## DEVELOPMENT REVIEW BOARD

### DEVELOPMENT REVIEW BOARD STAFF REPORT

<b>Hearing Date:</b> December 1, 2016	
<b>Case No:</b> DRB 2016-40	
<b>Application(s):</b> 2-lot Conventional Subdivision	
<b>Application Received:</b> October 17, 2016	
<b>Application Deemed Complete:</b> November 3, 2016	
<b>Staff Report Finalized:</b> Friday, June 5, 2015	
<b>Applicant(s):</b> Bartlett & Tara Greenfield 3 Cobble Hill Road Milton, VT 05468	<b>Owner(s):</b> Same
<b>Engineer/License:</b> Brad M. Ruderman & Associates, Inc Brad M. Ruderman/ PE#8821 LS#60854 28 US Route 5 N Windsor, VT 05489	<b>Surveyor/License:</b> Same
<b>E-911/Postal Address:</b> 60 Hobbs Road	
<b>Tax Map, Parcel(s):</b> 28, 41	
<b>School Parcel Account Number(s) (SPAN):</b> 13737	
<b>Deed(s):</b> Book 460, Page 460	
<b>Existing Size:</b> 1.3 acres	
<b>Zoning District(s):</b> Beaverbrook Residential "R7"	
<b>Comprehensive Plan Planning Area/Sub-Area:</b> Town Core Planning/ Eastern Transition Sub-Area	
<b>Location:</b> North Side of Hobbs Road between Meadow Road and Griswold Drive

**Noticed/Warned Summary of Proposal:** Bartlett & Tara Greenfield, Owners/ Applicants, request Sketch plan approval for a proposed Minor Conventi

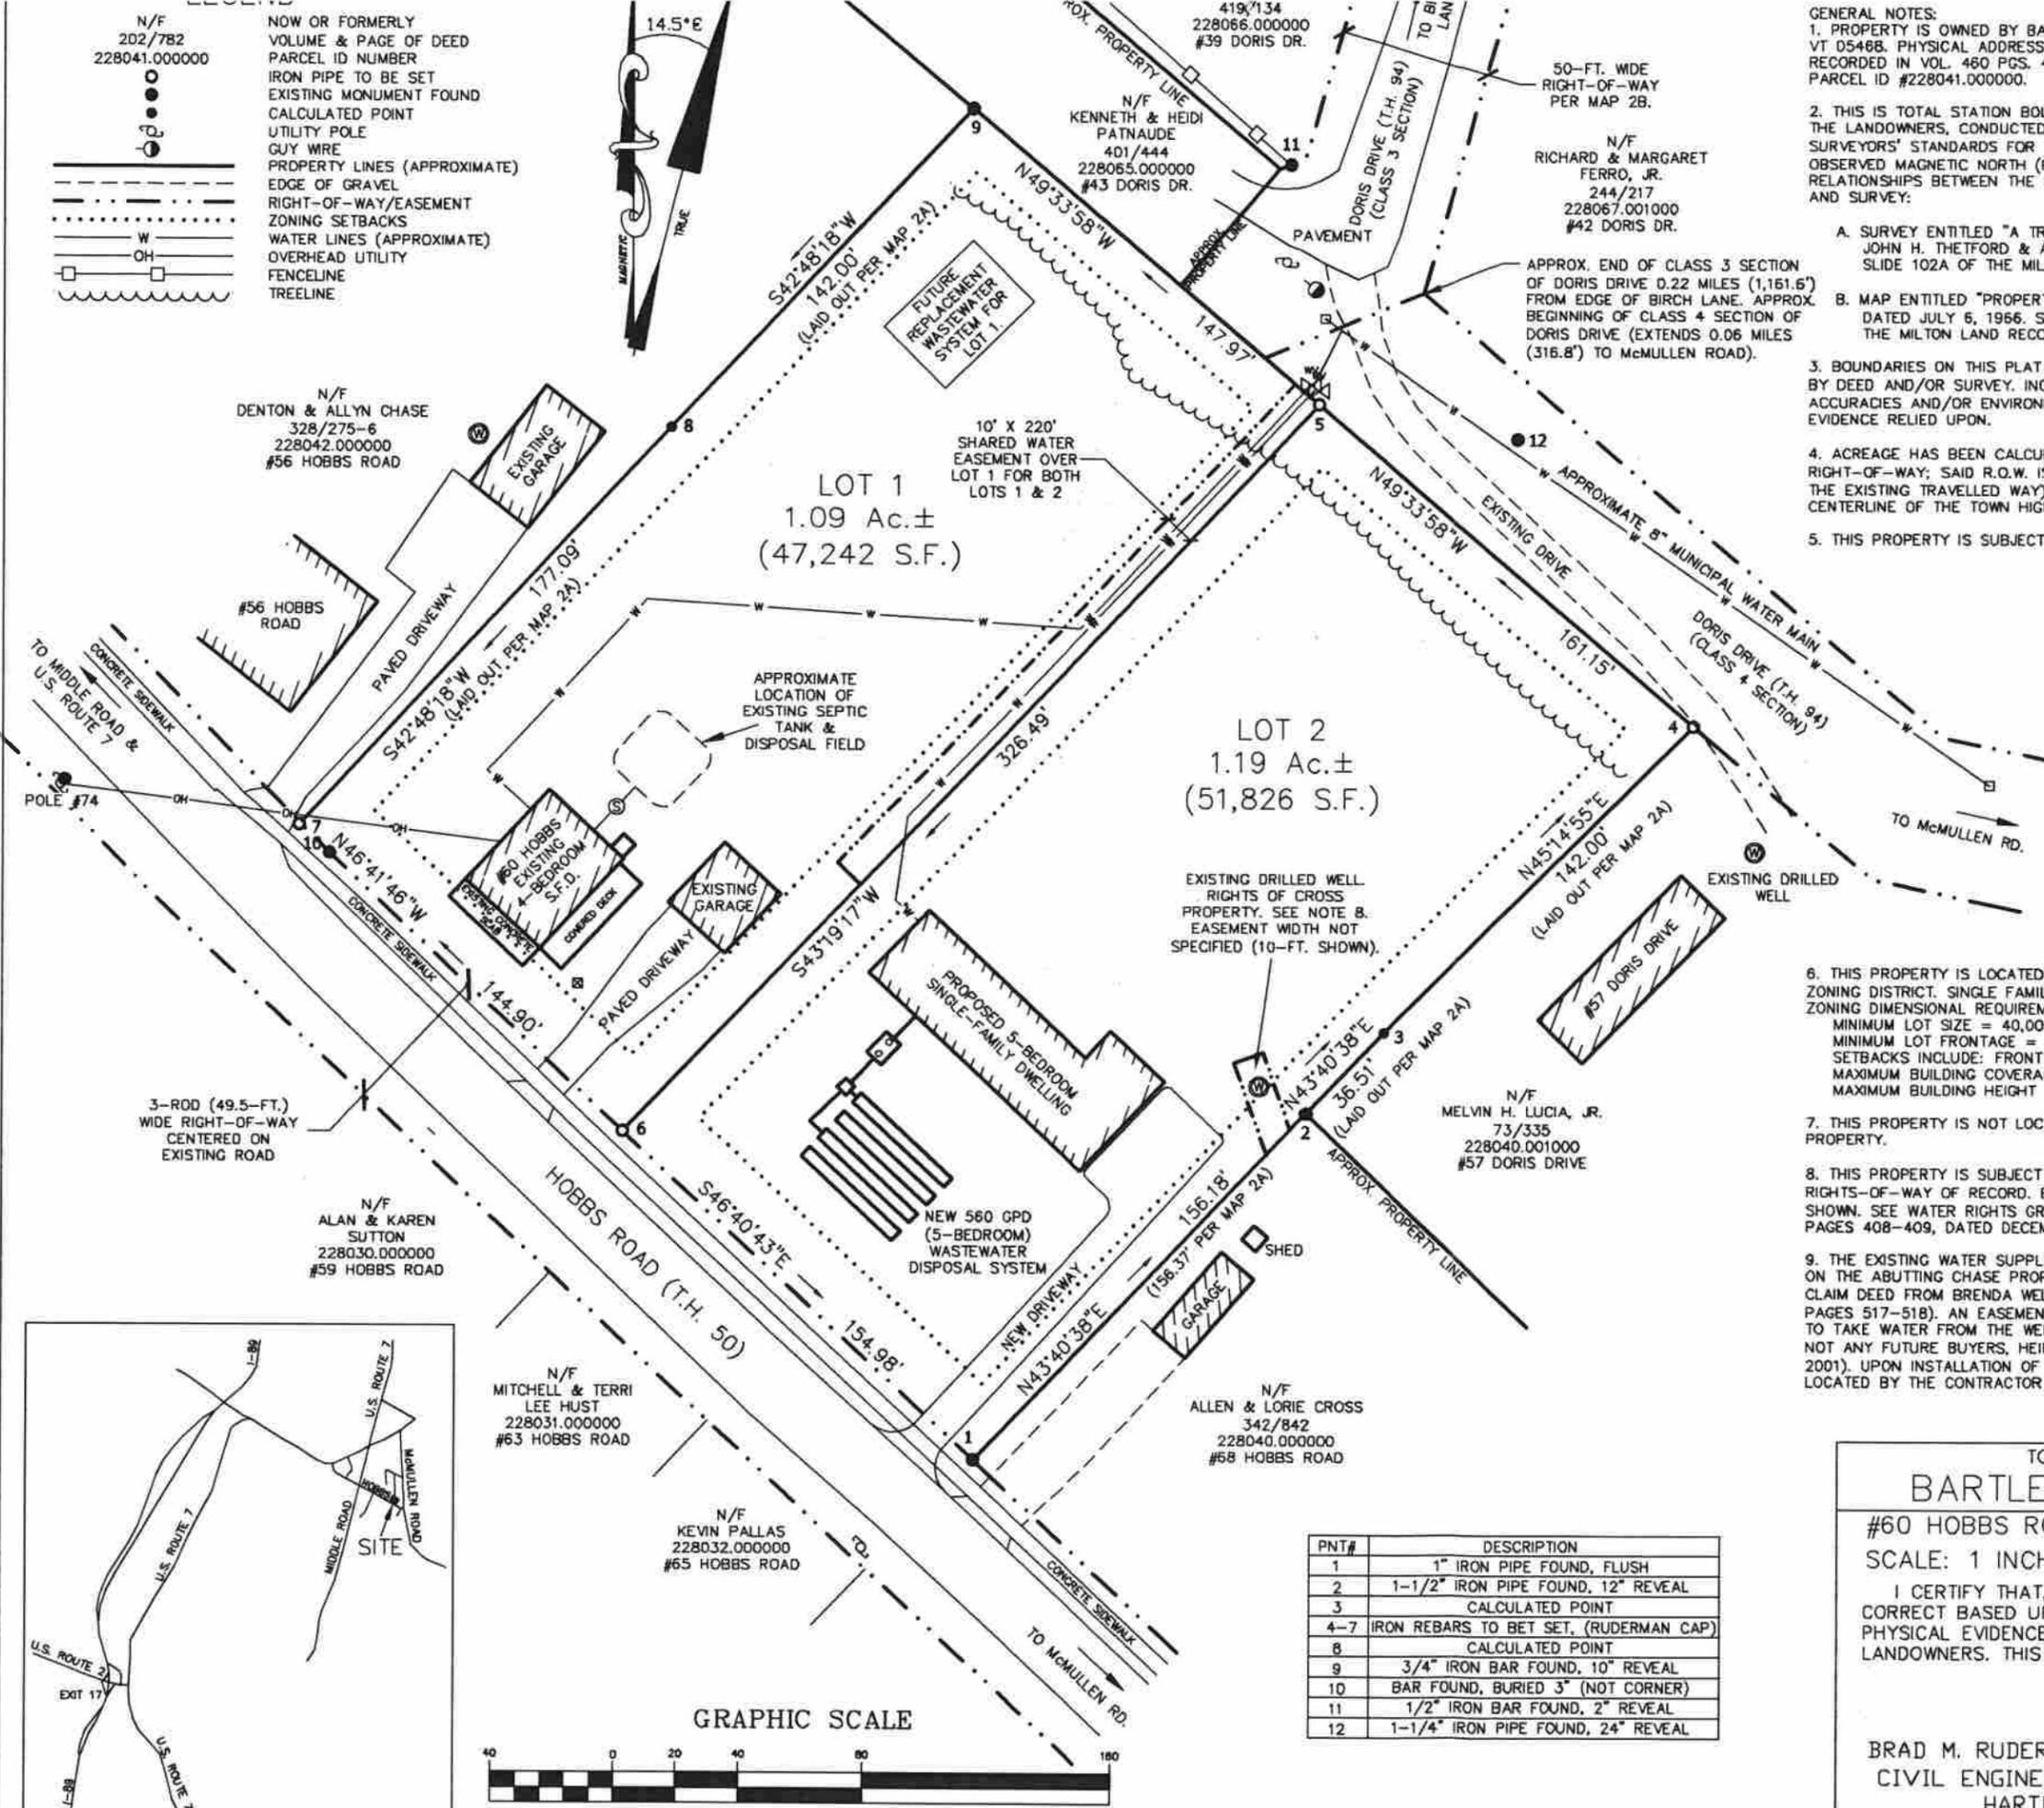
Staff finds that some shade trees are present on the subject property along Hobbs Road. A gap in the trees along the front of the property is predominantly located on the proposed lot 2. Staff further finds that this request is constant with Comprehensive Plan **Goal 9.1.2.** for the Town Core Planning area, which is to "Enhance streetscape elements by incorporating streetlights, **street trees**, and signage."

4. The DRB may require that street trees be planted along Hobbs Road in accordance with SR830 and consistent with Goal 9.1.2 of the Comprehensive Plan.
5. If required, the final plan application shall include the location of street trees along Hobbs Road pursuant to SR830.

DRAWN BY:	BGP	CHECKED BY:	MAD
SCALE:	1"=200'	FIELD BOOK:	335
DATE:	07-25-2016	DATE OF SURVEY:	05-24-2016
JOB NUMBER:	16021/16-067	SURVEY BY:	MAD/BGP/JRK
DRAWING:	16021SPLAT-TDH 16-067SPLAT-TCE	SHEET	1 of 1

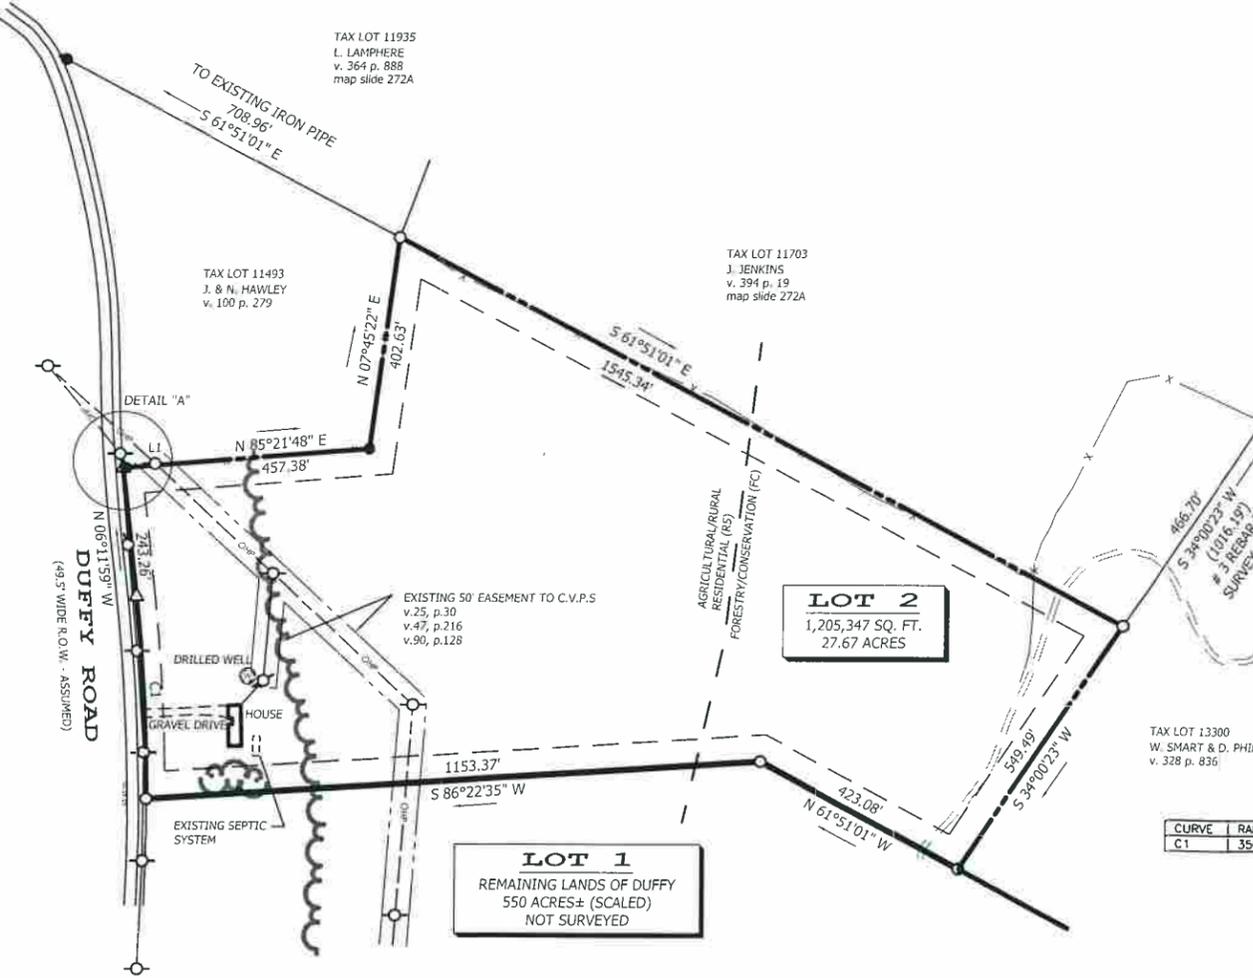
24. **Area Within Restrictive Easements/Right-of-Ways:** The applicant stated that there is encumbered land held by CVPS recorded in vol. 25/p. 30, vol. 47/p.216, vol. 90, p.28. No encumbered areas are shown on the draft plat. *The applicant agreed the final plat shall show the location & width of all easements.*

35. *The applicant agreed that the final plat shall show the mapped streams on the lots.*
36. Wetlands (Map 6): The applicant states that there are mapped wetlands approximately 800' easterly beyond the easterly line of Lot 2. Staff finds that no change to the existing land use is proposed that would impact the presumed wetlands.

54. Staff contests the application’s listing of the front setbacks as at least 35’. Based on online mapping measurements, it appears that two existing buildings on proposed lot 1 are non-conforming structures because they are set closer than 35’ from the Duffy Rd. property boundary; however, this subdivision would not make the buildings any more non-conforming than they are now, nor create any new non-conformities. *The applicant agreed that at final, the applicant shall revise the dimensional conformity tables to accurately describe the existing and proposed dimensions.*

55. Staff finds that the proposed frontage is listed as 623 feet in the application, but it is shown on the plat as 243.26’. In looking at the plat’s scale, it appears that a dimension may have been covered by another CAD layer when the Plat was prepared for printing. *The applicant agreed that final plans shall show the dimensions between each pin in order to enable the DRB to evaluate the frontage and size of the lot. Further, the applicant stated they are already included on the sketch plan, and clarified the length in questions is identified as C1 in the curve table.*

**Item 1:** The easement widths have been added to the final plat. The easements continue onto Lot 1 which is the remaining lands east of Duffy Road; the locations are note shown on Lot 1 due to the physical locations were not field located.

**Item 3:** Mapped streams were added to the overall parcel layout portion of the final plat.

**Item 4:** All information west of Duffy Road was removed and a note in the dimensional table was added to inform that the project is located on the east side of Duffy Road only.

**Item 5:** Dimensional table was revised per comments, the two structures on Lot 1 were 32 and 33 feet from the right of way; the lesser of the two is shown in the dimensional table.

**Item 7:** The locations of all wastewater systems and potable water sources are shown on the final plat although small; see overall parcel layout. The subdivision has been granted approval from the State and has been permitted under WW-4-4723. Approved replacement areas of designation are shown on the plans submitted within that application and are readily available from the States' permit search website.
